ITEM #	QTY	NEWMAR #	DESCRIPTION
1	1	136982	MONITOR PANEL NADP 18

Revision: REVERSED THE DRIVER AND PASSENGER AWNINGS SWITCHES AND ADDED By: B. B. Model: Sheet Drawn by: Checked by: NEWMAR CORP NADP J. S. R. W. P.O. Box 30, Nappanee, IN. 46550 RESISTOR NOTE PER (PCR #180630) Date: 5/30/17 I.D. # 2018\ DP\CODE\ELEC\ NA_MONITOR_PANELS Title: Date: Date: Revision: CHANGE LOCATION OF SWITCHES, DIA. CONN. AND WINEGARD CONTROL By: D. F. UNITS: INCHES MONITOR PANEL 12/29/16 Date: 2/14/17 TITLE BLOCK: 1-4FULTB REVERSED THE LOCATION OF THE SLIDE OUT SWITCHES

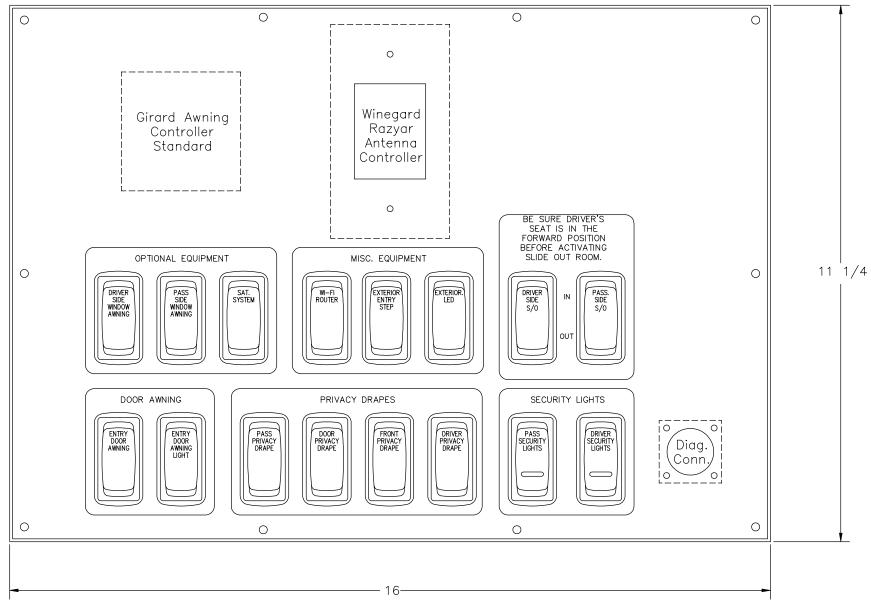
NO RESISTORS ON SLIDEOUT SWITCHES
